SERVICE LETTER

No. 650

Inspection of Landing Gear Retraction and Flap Control Transmission Assemblies

SUBJECT: Identification of Serviceable/Non-Serviceable Landing Gear Retraction and Flap Control Transmission Ball Screws

Flap Control Transmission Assembly

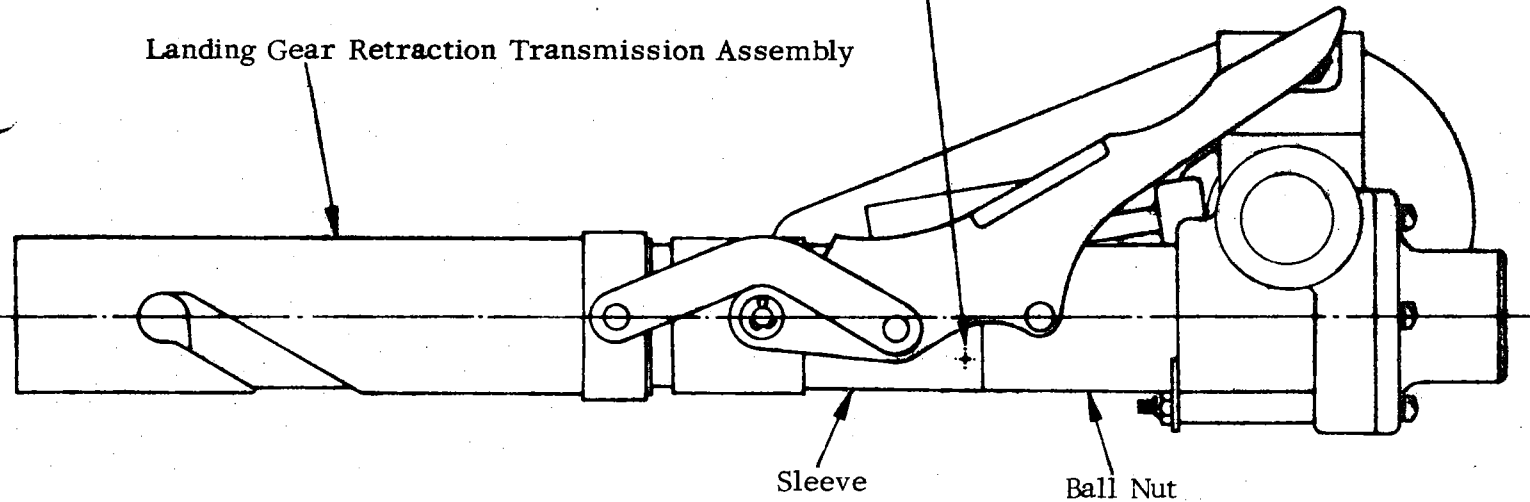
Sleeve must be staked at three points
(on circumference of sleeve) to prevent
separation of threaded joint.

1. Refer to the appropriate Service Manual and gain access to the flap control transmission (if installed) and the landing gear retraction transmission.
2. Inspect transmissions to determine if sleeve has been properly staked as shown on above sketch.
3. If the transmission sleeves have been properly staked, no further action is required.
4. If either of the transmission sleeves have not been staked, it will be necessary to remove the transmission from the airplane and stake as shown (sleeve must be tight against ball nut before staking). Use a center punch and carefully stake to a depth of .030 to .040 inches. Refer to the appropriate Service Manual for proper Removal and Installation Procedures.

- REFERENCE SERVICE LETTER NO. 650: Purpose II
Identification of Transmission Ball Screw;
Transmission serial numbers 919 thru 1068 inclusive.

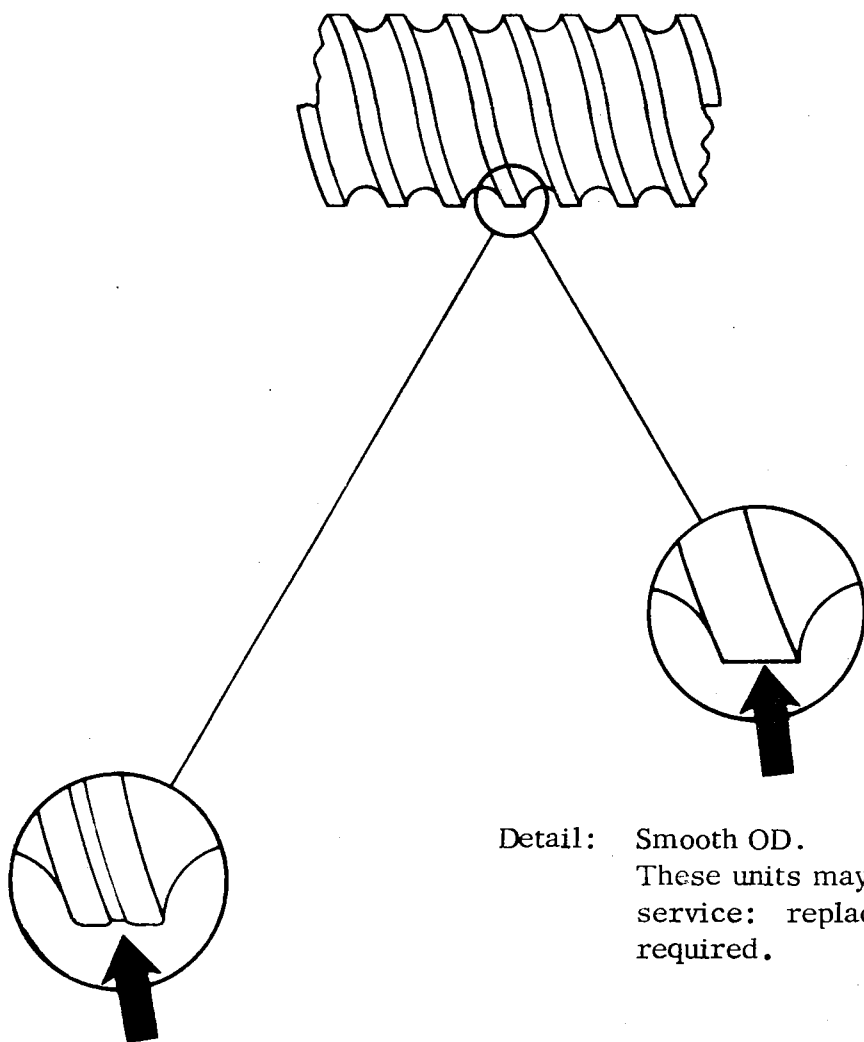
Subsequent to publication of Piper Service Letter No. 650, it has been determined that not all of the above referenced transmission assemblies require replacement. An inspection procedure has been provided by the manufacturer to determine if the transmissions referred to above need to be replaced. Details are specified below and on the sketch on the reverse side of this communication.

1. Expose the threaded ball screw portion of the transmission assembly to view.
2. With a magnifying glass, inspect the threads as specified on the sketch on the reverse side of this communication.
3. Refer to the "detailed" call-outs on the sketch to determine whether the transmission assembly must be replaced.
4. Refer to the balance of Piper Service Letter No. 650 for replacement material identification data.

Detail: Smooth OD.
These units may remain in service: replacement not required.

Detail: Grooved OD.
These units must be replaced.
